**From:** [Odin](#)  
**To:** [TAM Info](#)  
**Subject:** Public Comment - 2/12 Administration, Projects & Planning Executive Committee Meeting - Item 5  
**Date:** Saturday, February 10, 2024 5:01:40 PM

**From:** [Matthew Hartzell](#)  
**To:** [Jennifer Doucette](#)  
**Cc:** [Patrick Seidler](#)  
**Subject:** Comments re: TAM APP ExComm 2-12-24 meeting Agenda item 7  
**Date:** Monday, February 12, 2024 9:36:04 AM  
**Attachments:** [WTB.01\\_NaveDr\\_concepts.pdf](#)

## Nave Dr. Bike tunnel visualisation (suggested options for the visualisation)

Option 01 - Retaining walls both sides.

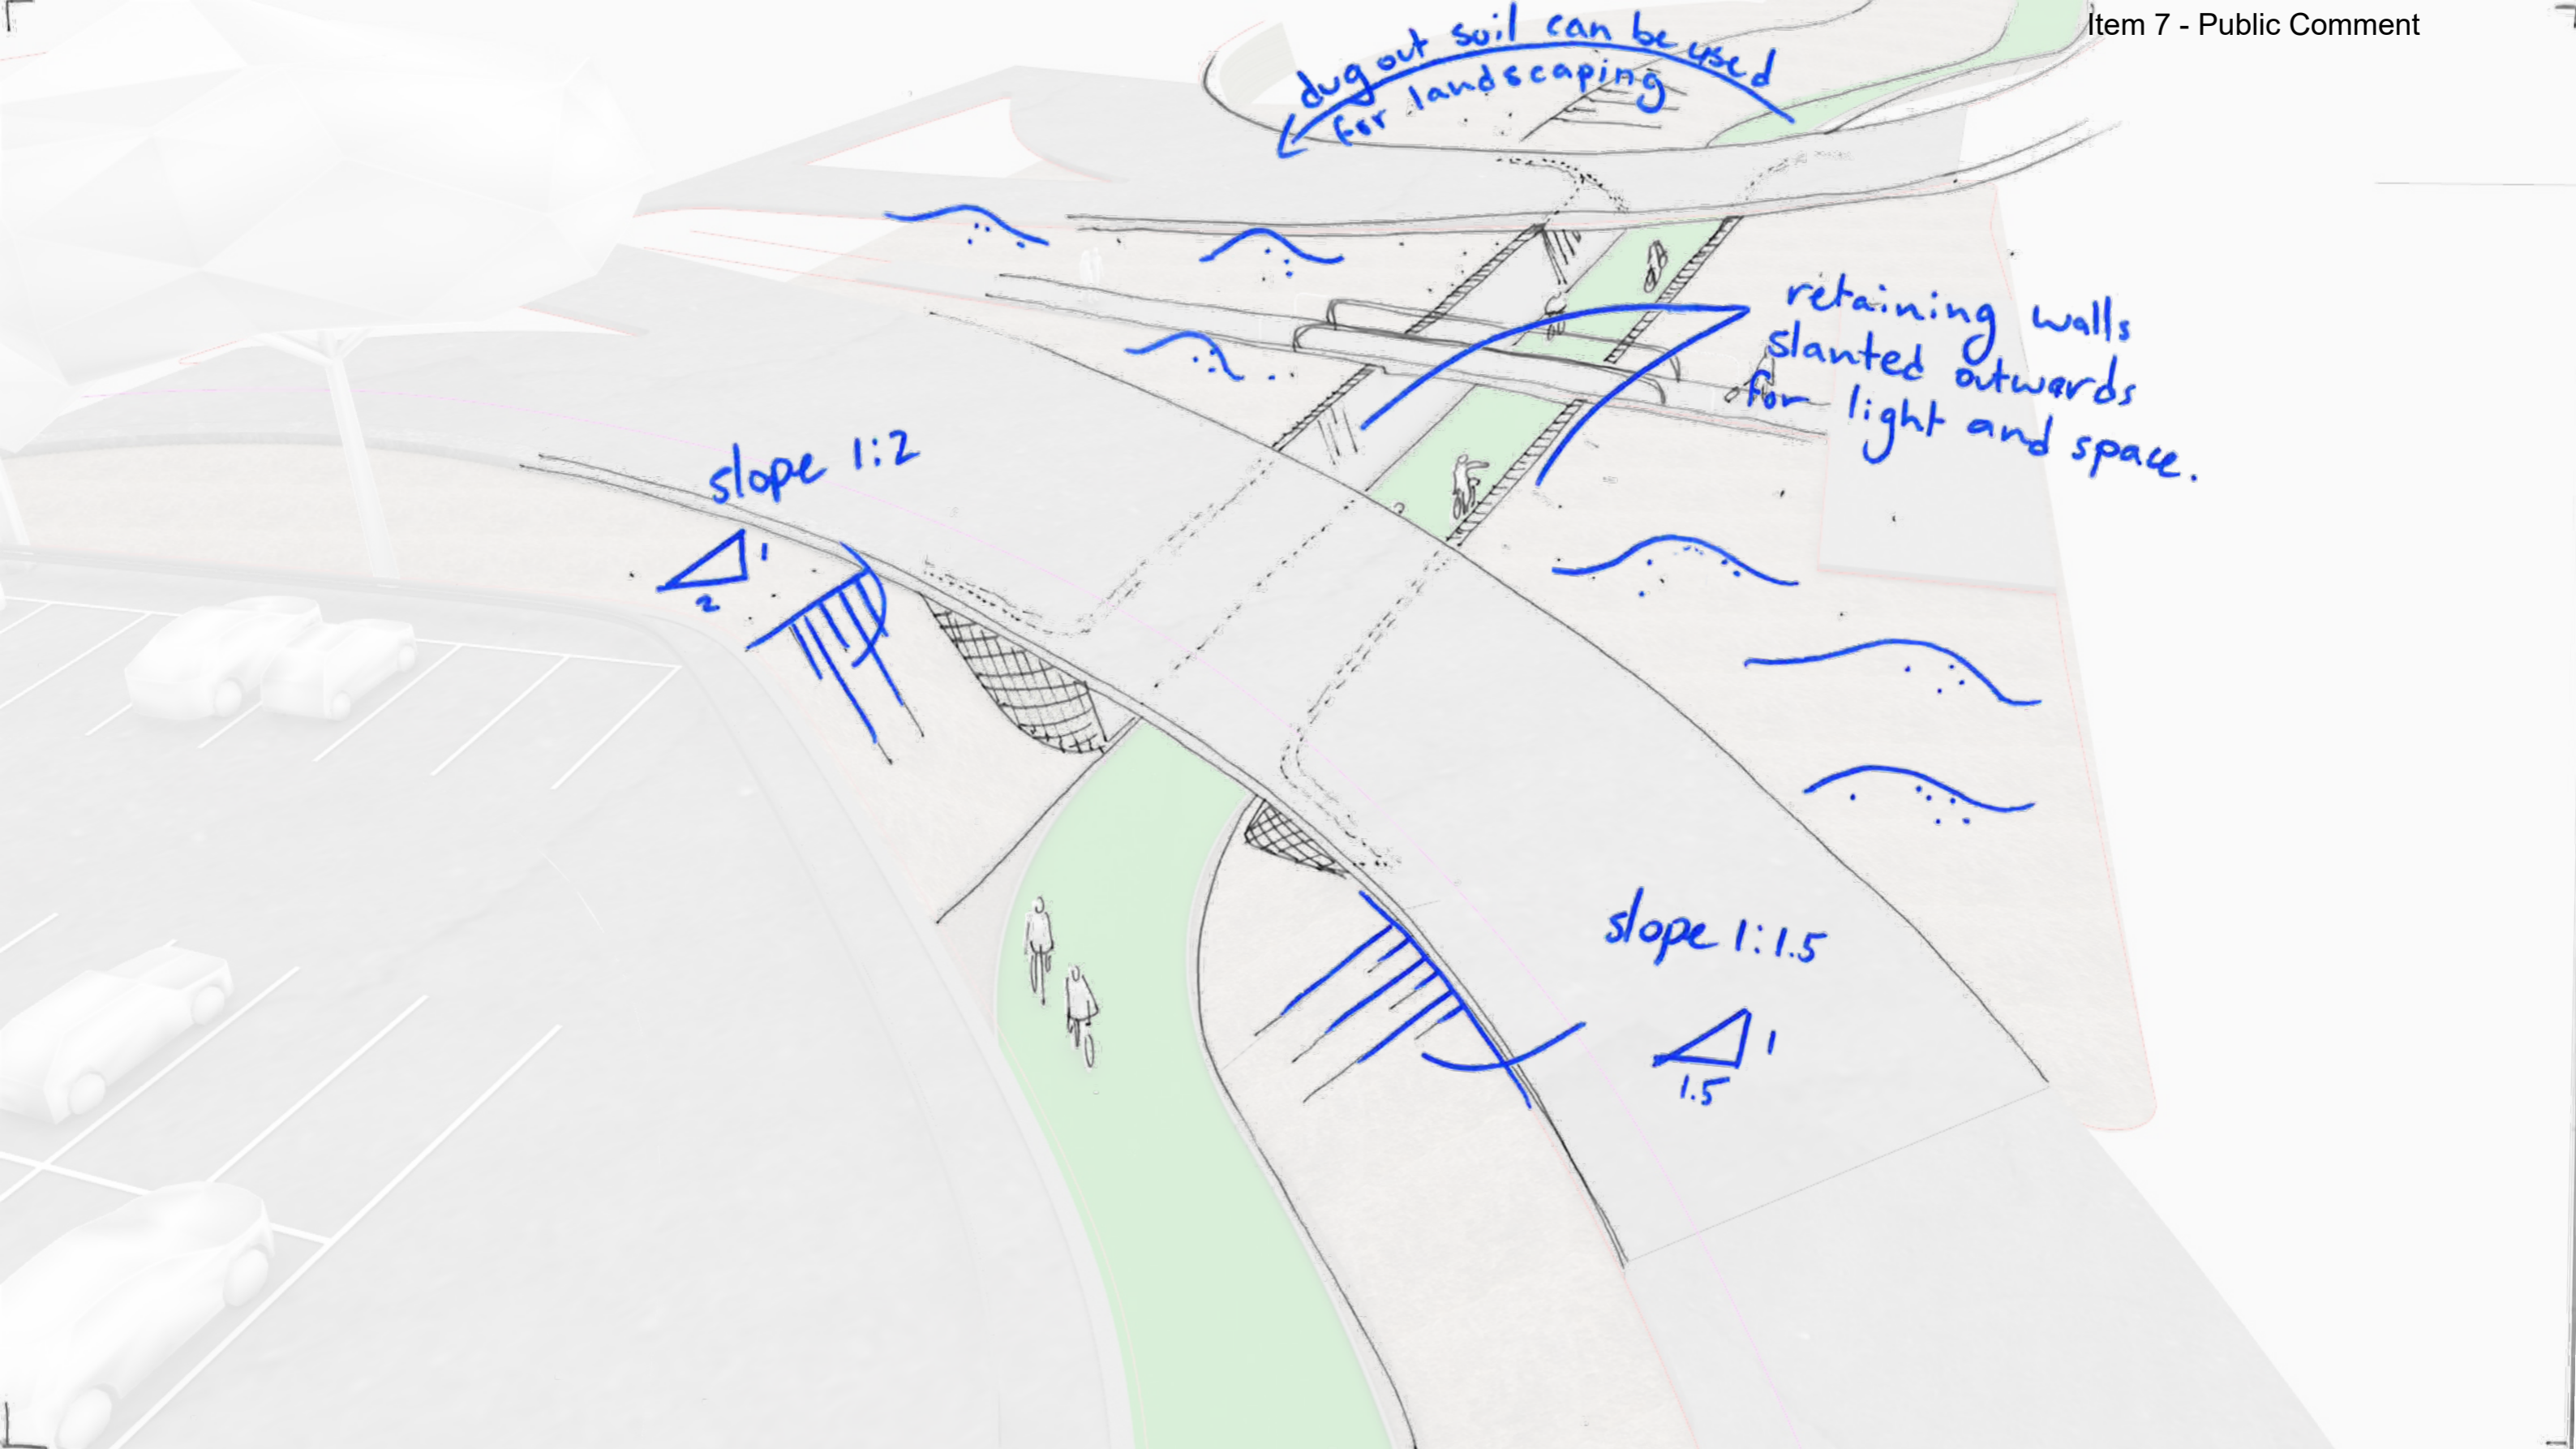
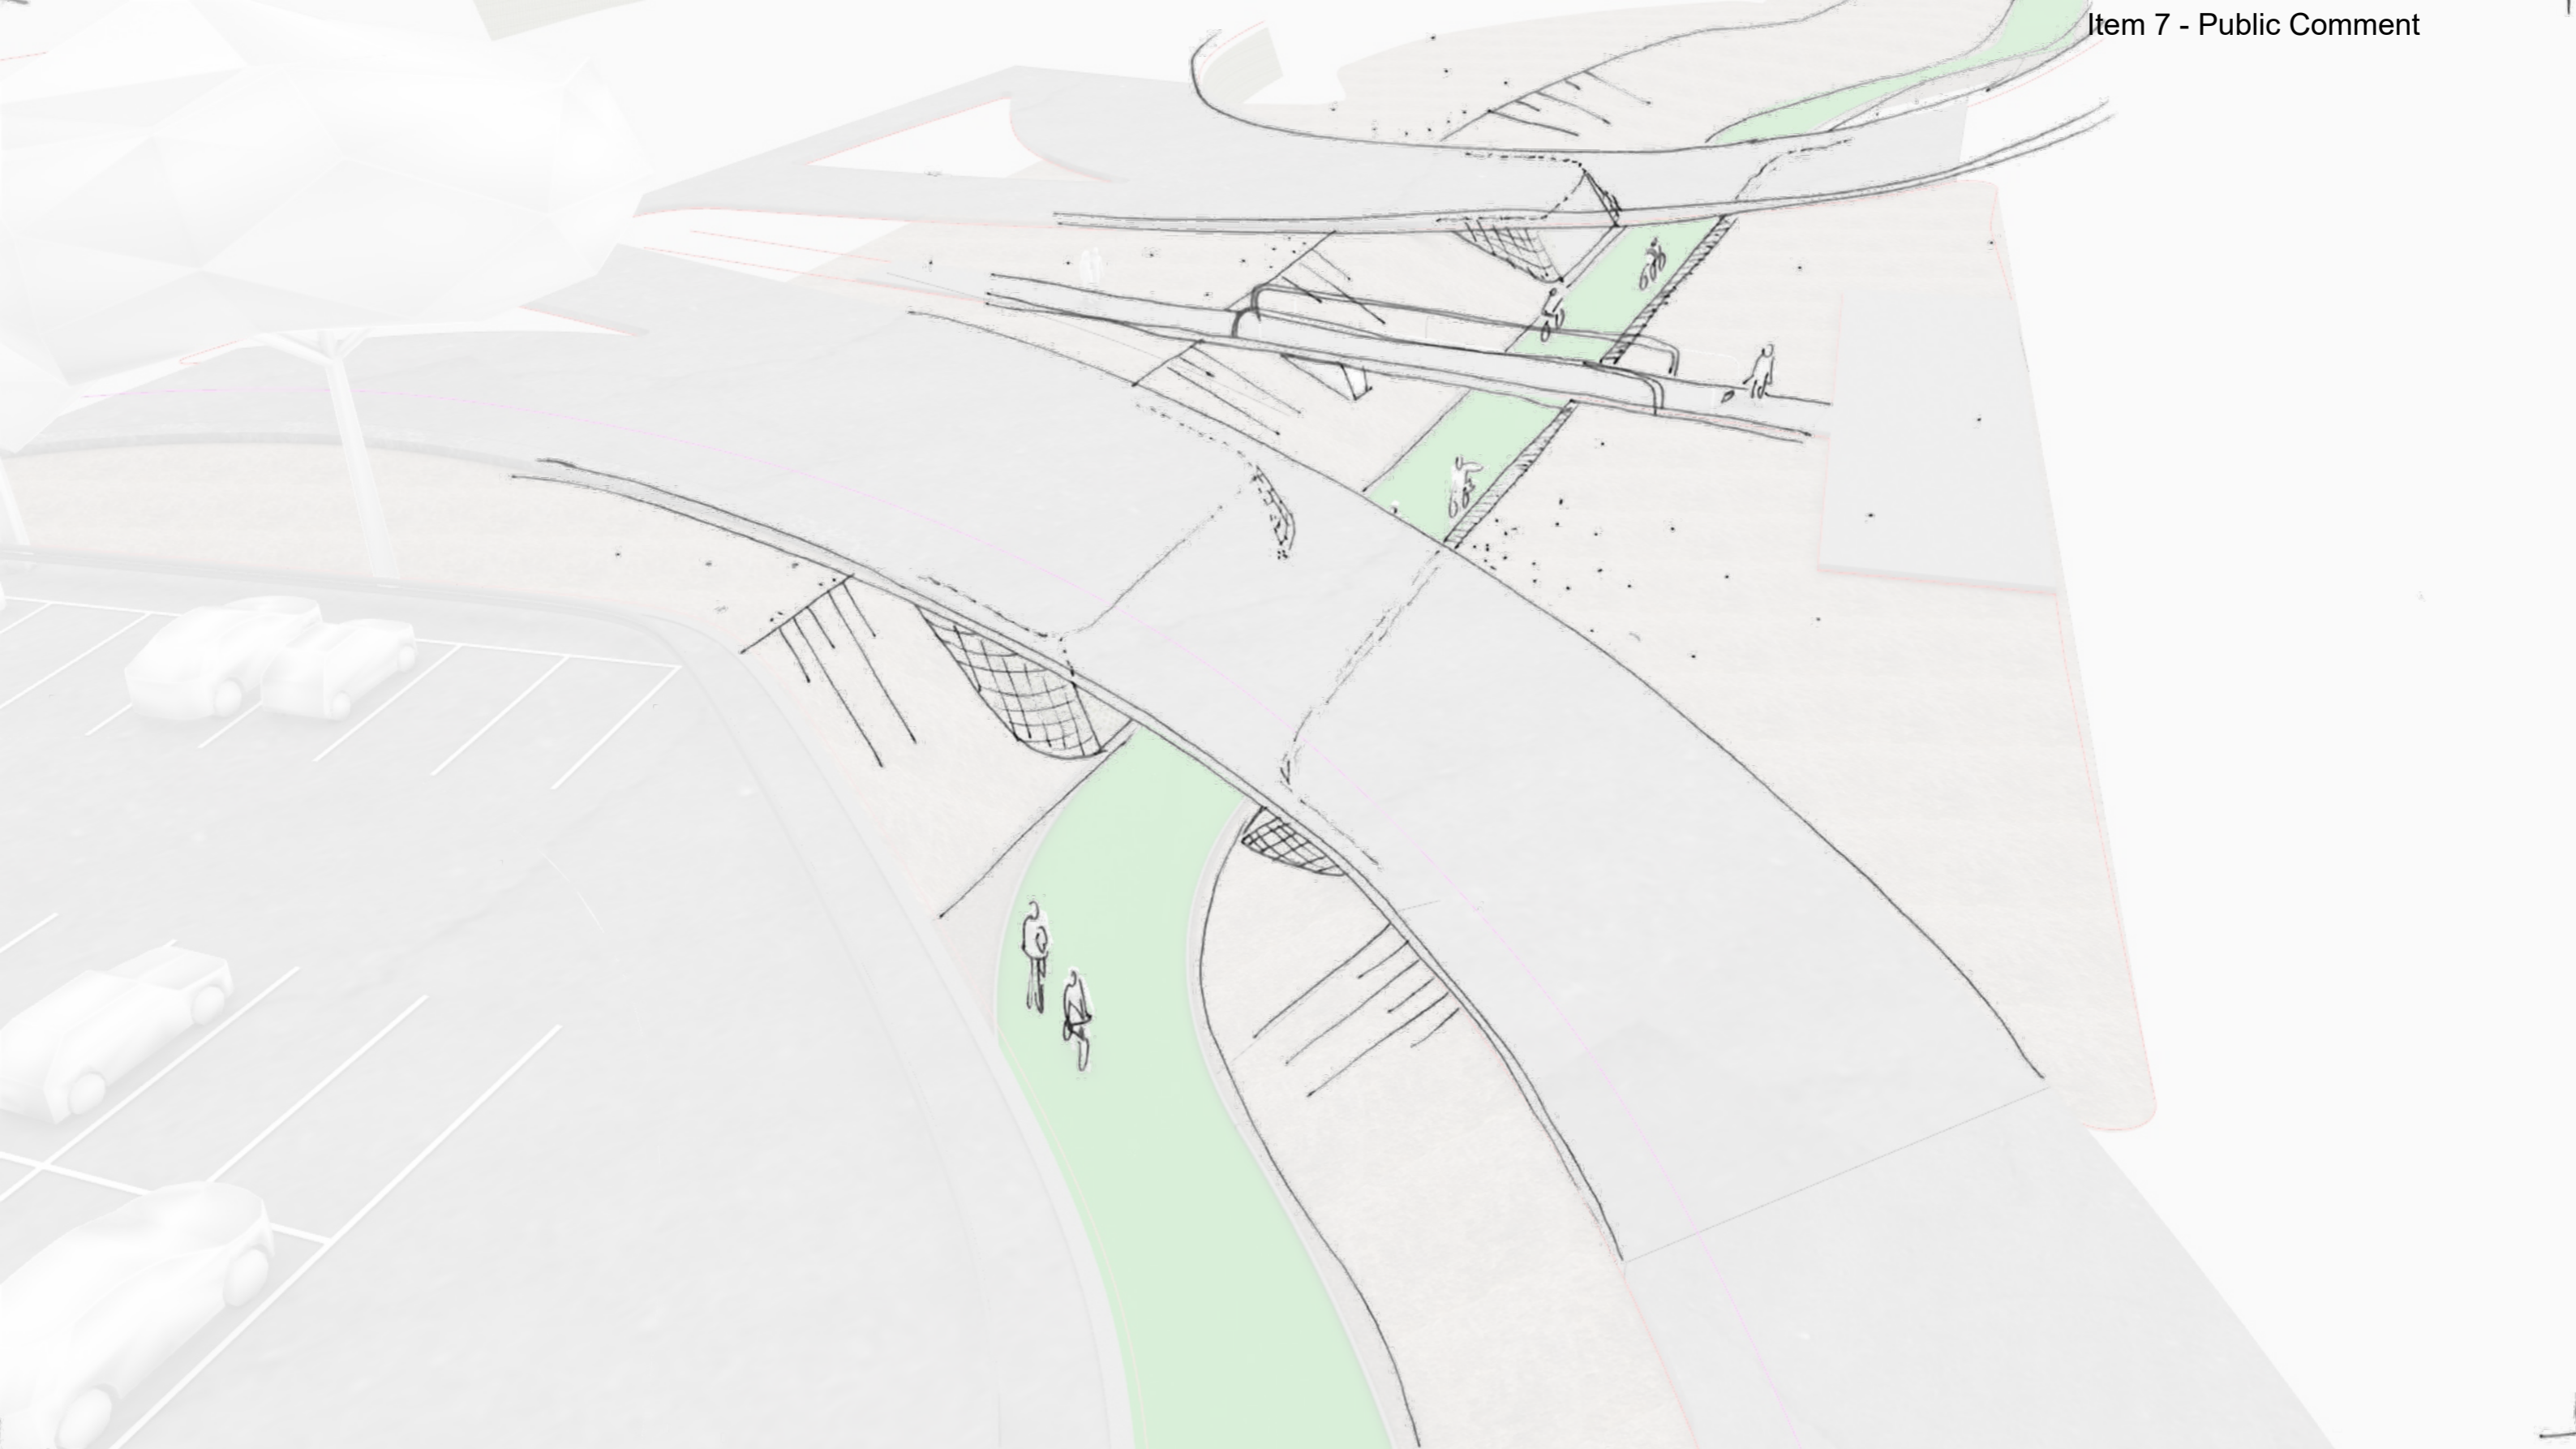
- Trees on site. The chosen alignment closely passes trees, the roots of these trees are likely to be encroaching into the path. Therefore, it is expected that 1-2 trees would need to be removed (at SouthWest tunnel entrance).
- MEP is not checked. The presence of mechanical, electrical and plumbing could hinder the construction.
- Water levels are not checked. It is important to prevent water logging in tunnels, the tunnel construction might be limited to option 1 if water is an issue. Option 1, tunnel with retaining walls could be designed to function as barriers against the tunnel flooding.
